Our Job Number: 220502
15 June 2023

Council Ref: DA2023/0185 & DA2021/1469

STORMWATER MANAGEMENT REQUIREMENTS

AT 23-25 LOCH STREET, FRESHWATER NSW

Figure 1.0 - Calculation Summary of the Development DRAINS Model

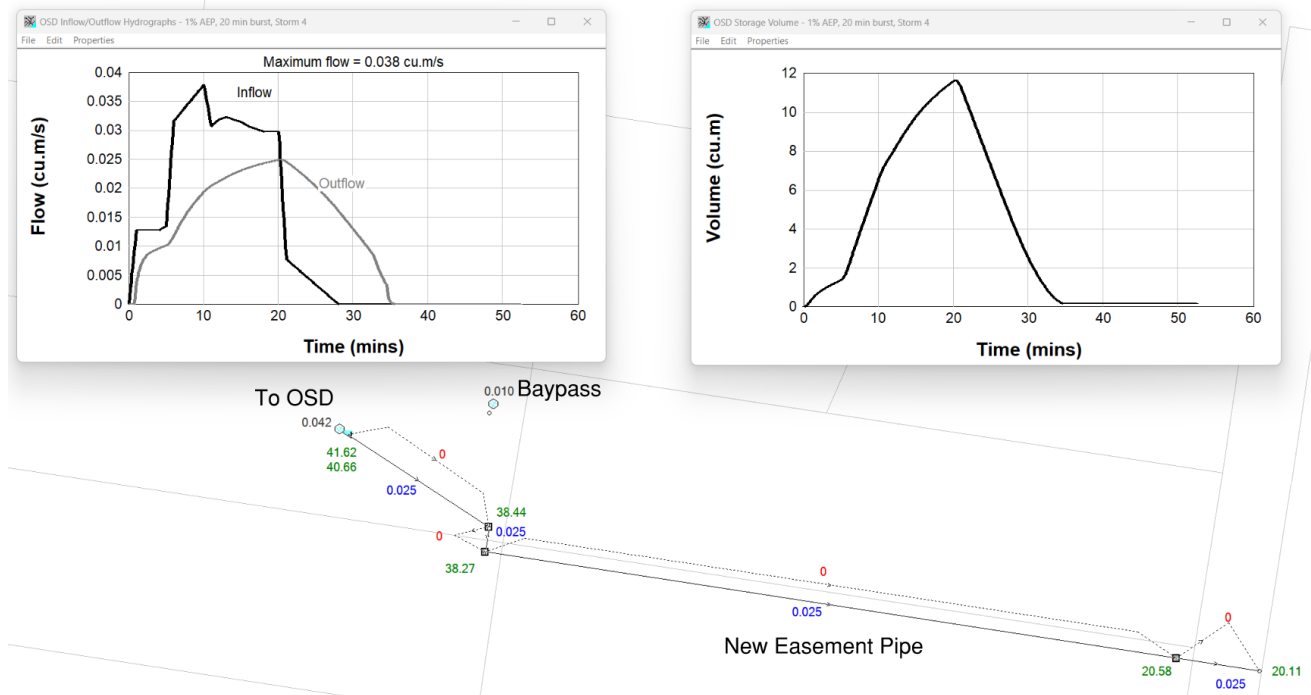
- d. Figure 1.0 of this report considers a summary of the hydrologic and hydraulic calculations. Calculations indicate that the Council required PSD is achieved for the proposed development. It can be seen from the DRAINS model that the Council required volume exceeds the minimum OSD requirements. Therefore, it is proposed to adopt the DRAINS model results of 11,600L.
